HISTORIC AND DESIGN REVIEW COMMISSION

October 03, 2018

HDRC CASE NO: 2018-472
ADDRESS: 410 BARRERA
414 BARRERA
LEGAL DESCRIPTION: NCB 926 (EIM LAVACA), BLOCK 4 LOT 32
NCB 926 (EIM LAVACA), BLOCK 4 LOT 33
ZONING: IDZ, H
CITY COUNCIL DIST.: 1
DISTRICT: Lavaca Historic District
APPLICANT: Nate Manfred/French and Michigan
OWNER: EIM Partners
TYPE OF WORK: Construction of additions, exterior modifications, site work
APPLICATION RECEIVED: September 06, 2018
60-DAY REVIEW: November 05, 2018
REQUEST:

The applicant is requesting conceptual approval to:

PROPOSED MASSING MODELS

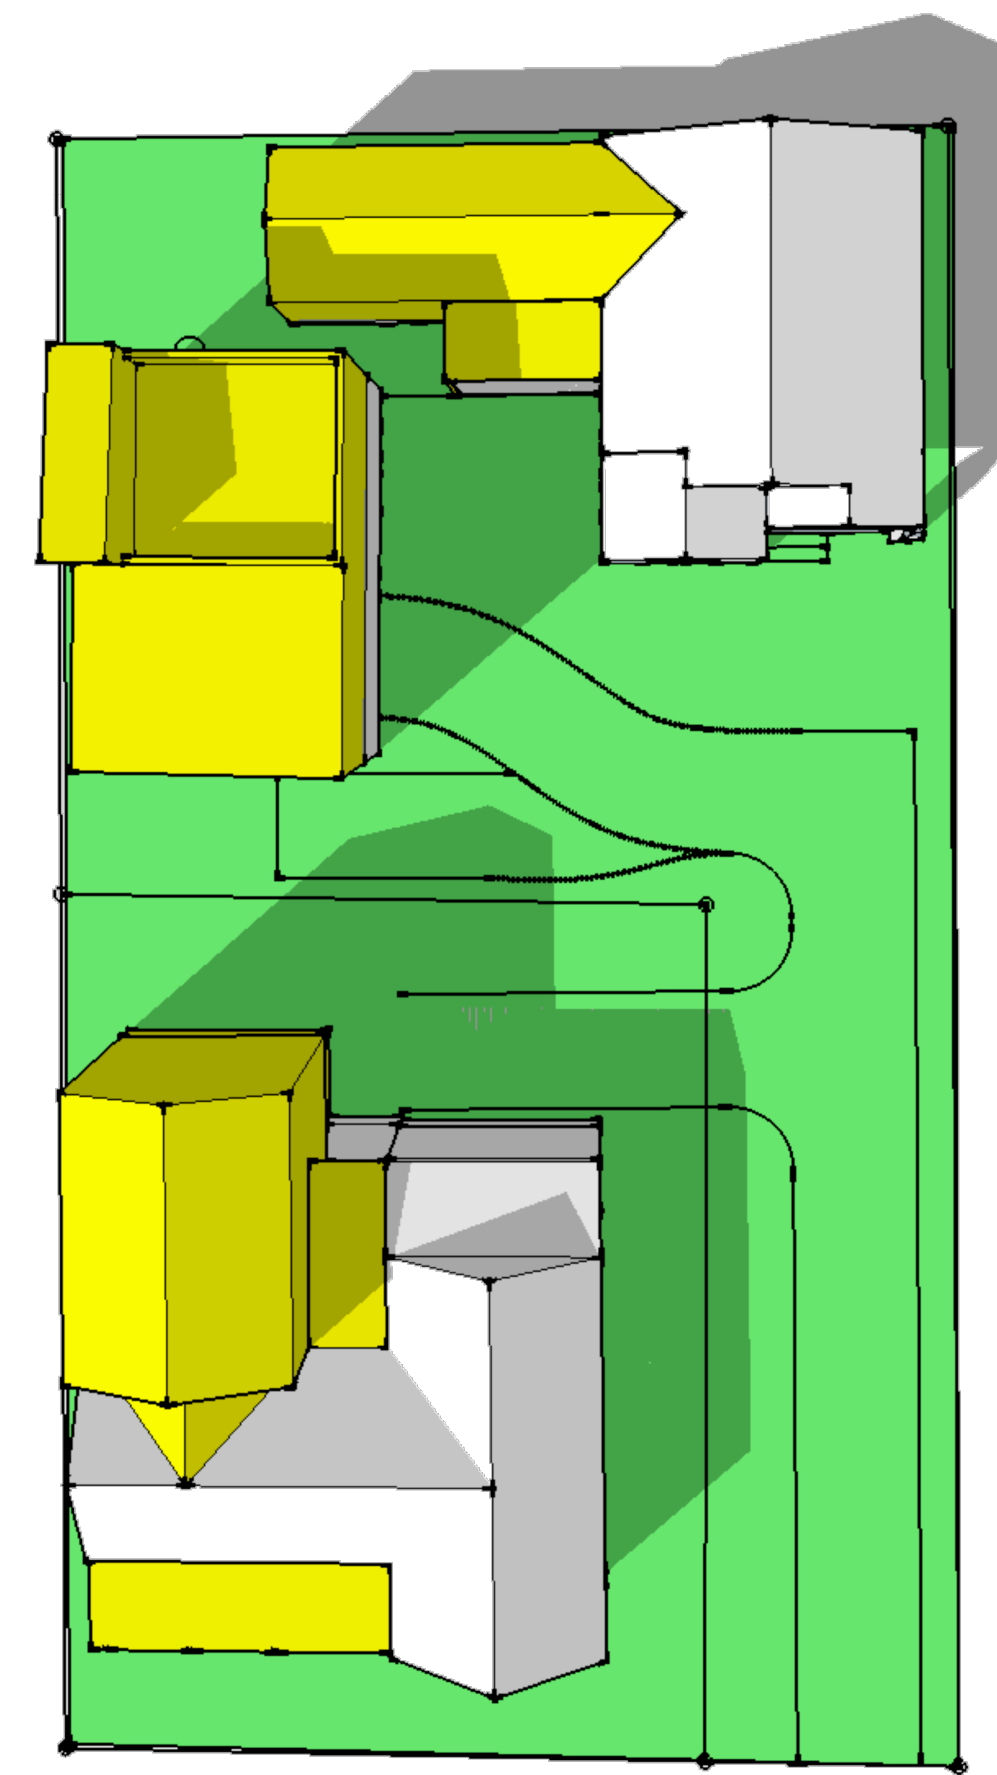
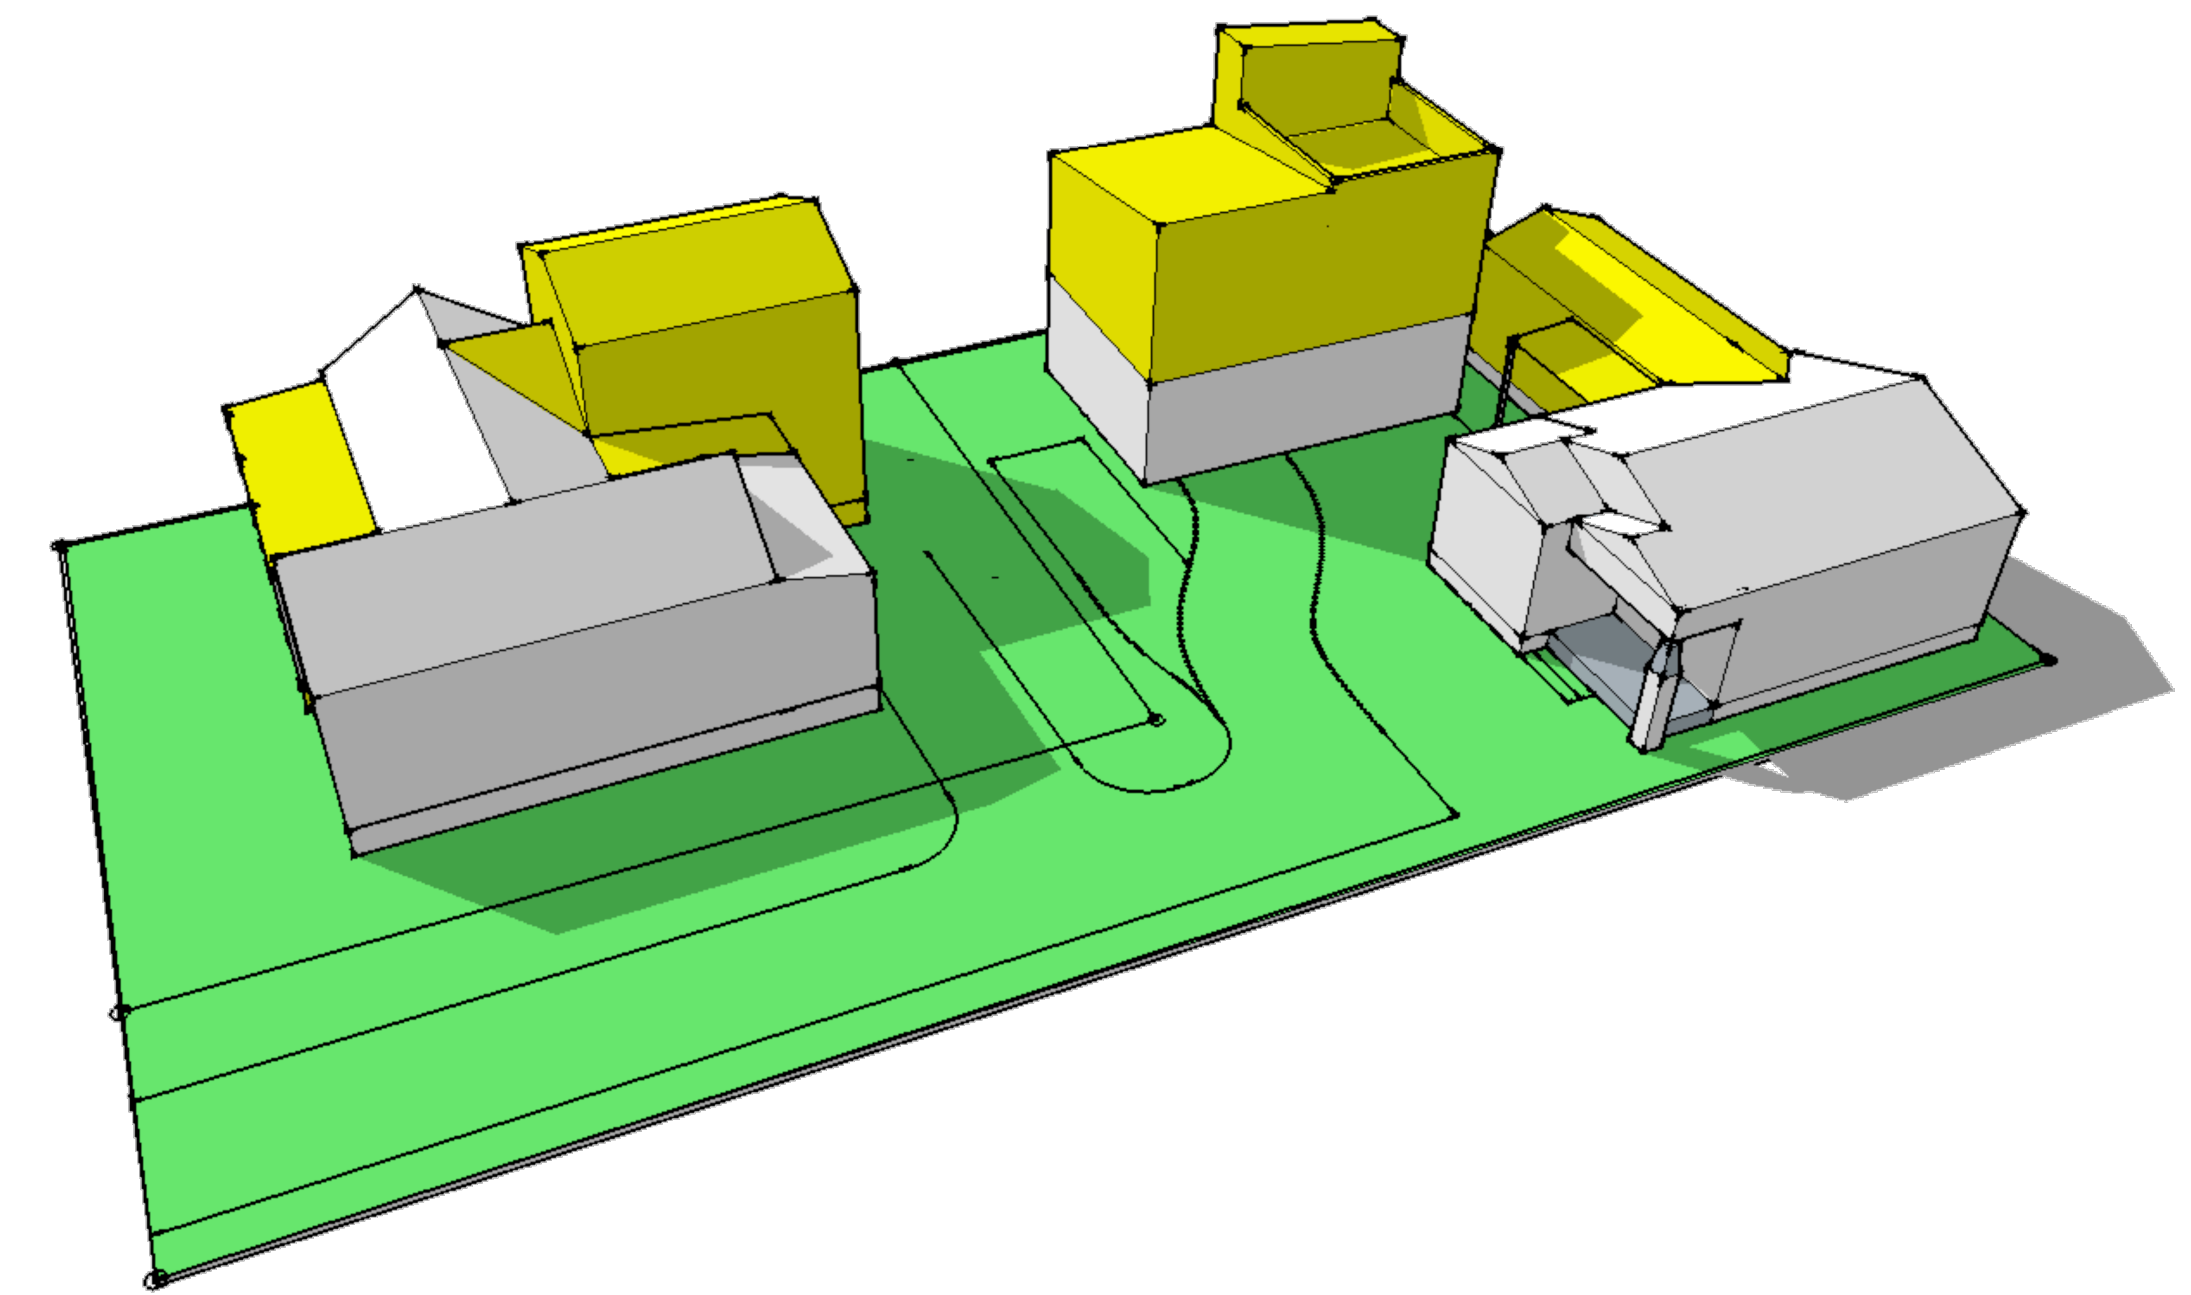
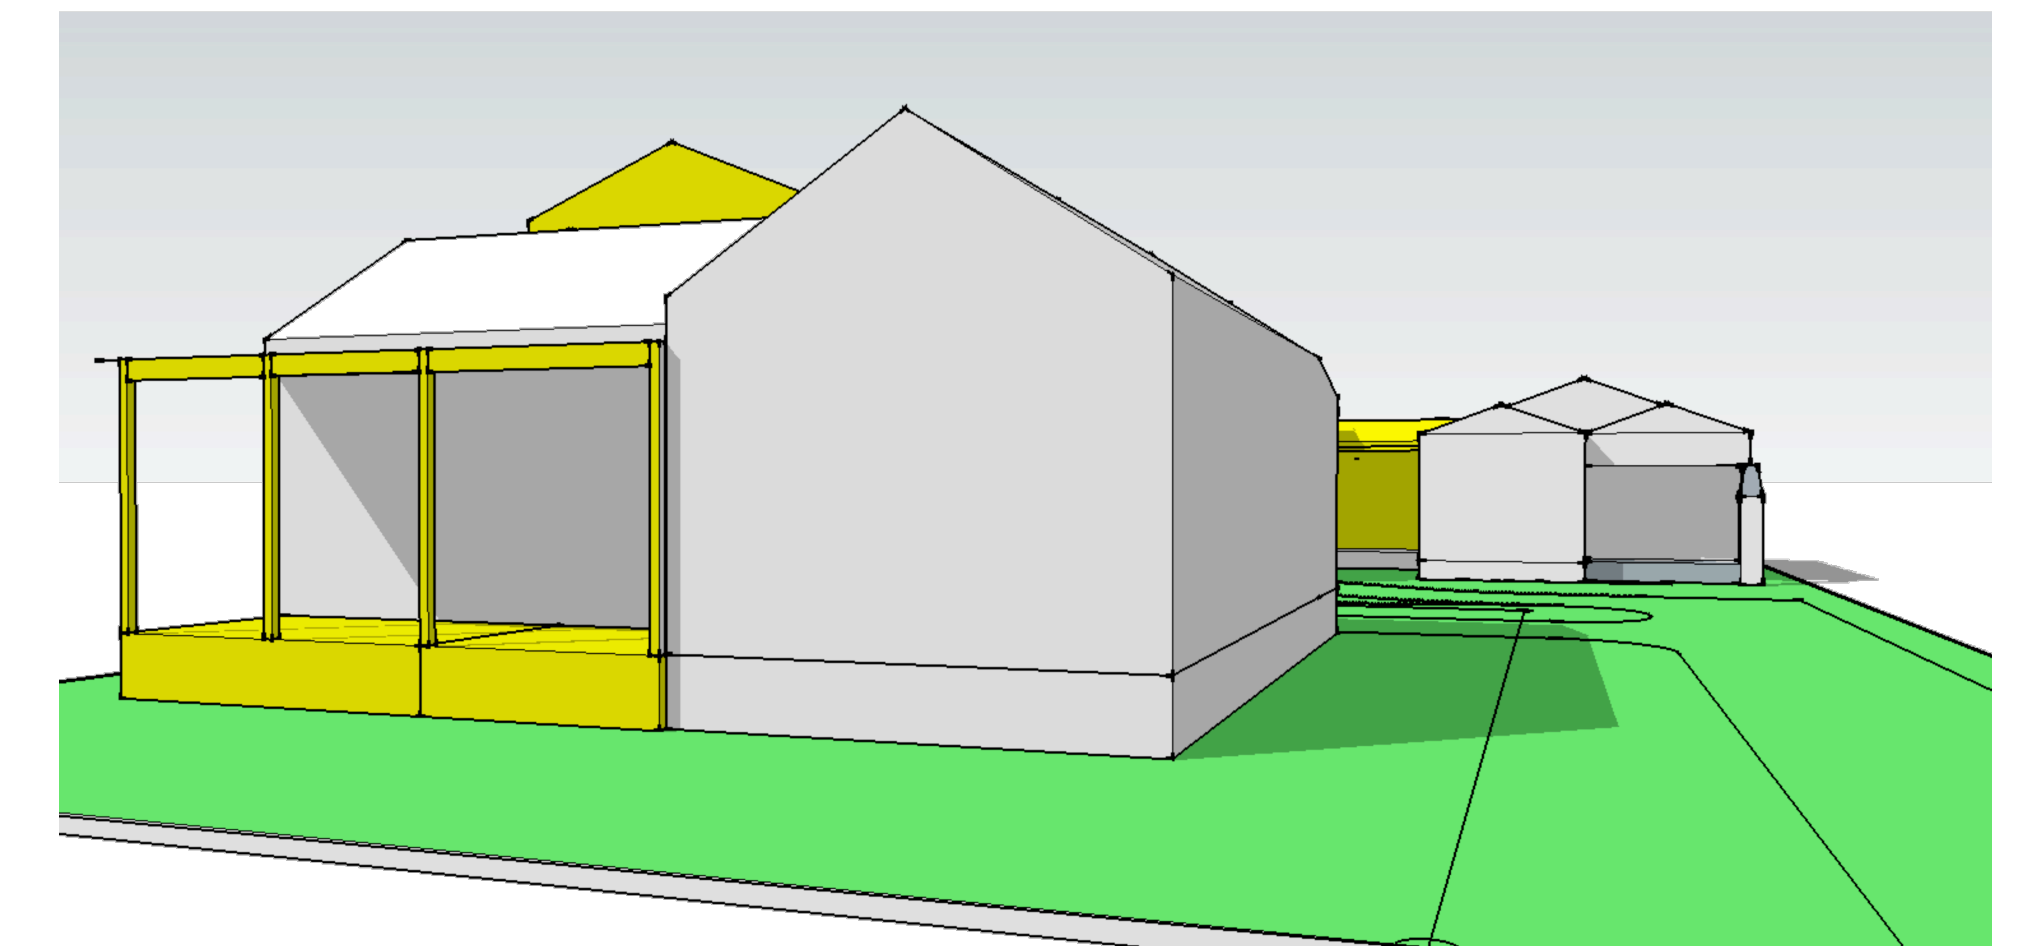
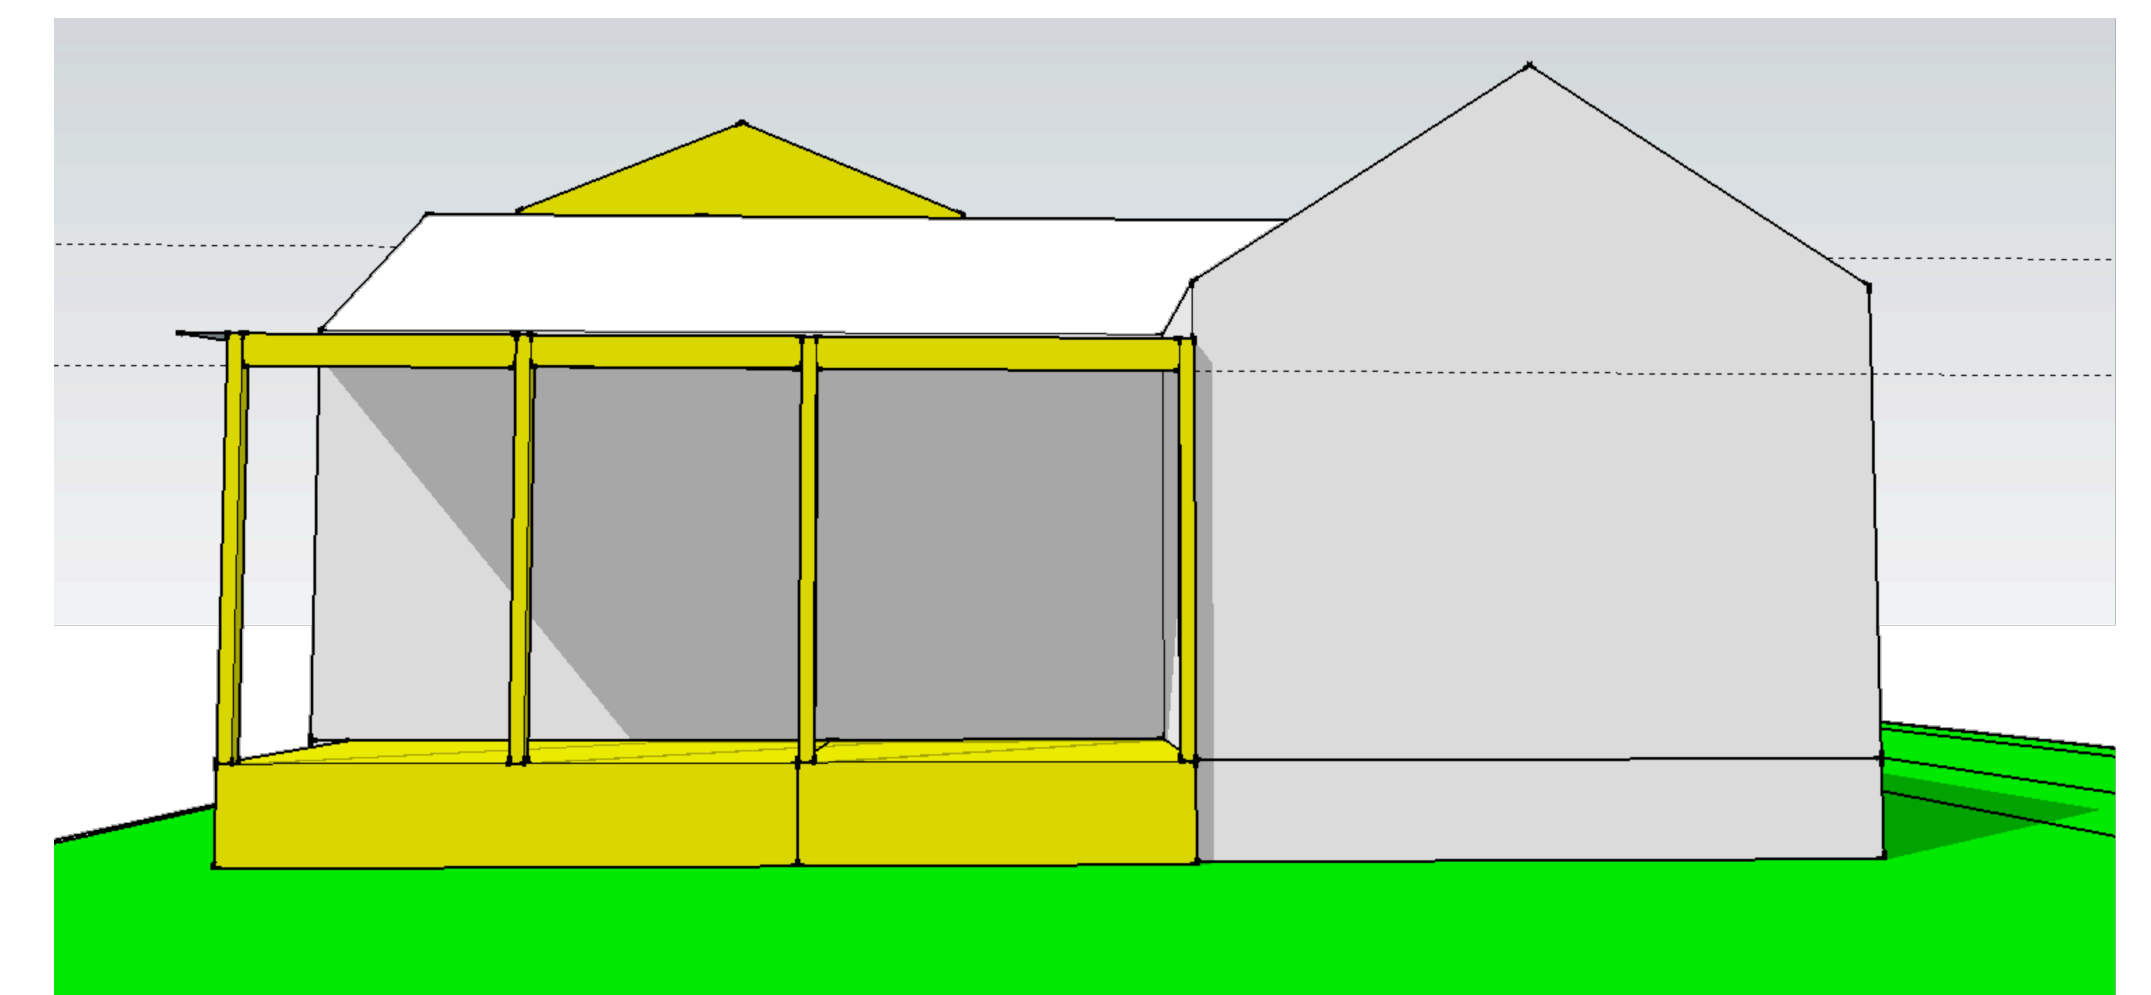
- 1a. PORCH RECONSTRUCTION (414 Barrera) – The applicant has proposed to reconstruct the front porch at 414 Barrera. The porch is shown on the 1904, 1912 and 1952 Sanborn Map. The Guidelines for Exterior Maintenance and Alterations 7.B.v. notes that porches should be reconstructed based on accurate evidence of the original and the architectural style of the structure. The applicant is to adhere to the Guidelines regarding porch reconstruction. Per the submitted massing models, the proposed porch features a form and massing that's appropriate.

- 1e. SCALE, MASS & FORM – Regarding scale, mass and form, the applicant has proposed an addition that in footprint is appropriate. Staff finds that the applicant should provide a line of sight study from the right of way at Barrera to document the level of visibility of the proposed two story addition.

- i. That the applicant submit perspectives or a line of sight study to ensure that the proposed addition will not impose on the front façade from the sidewalk and right of way at Barrera.
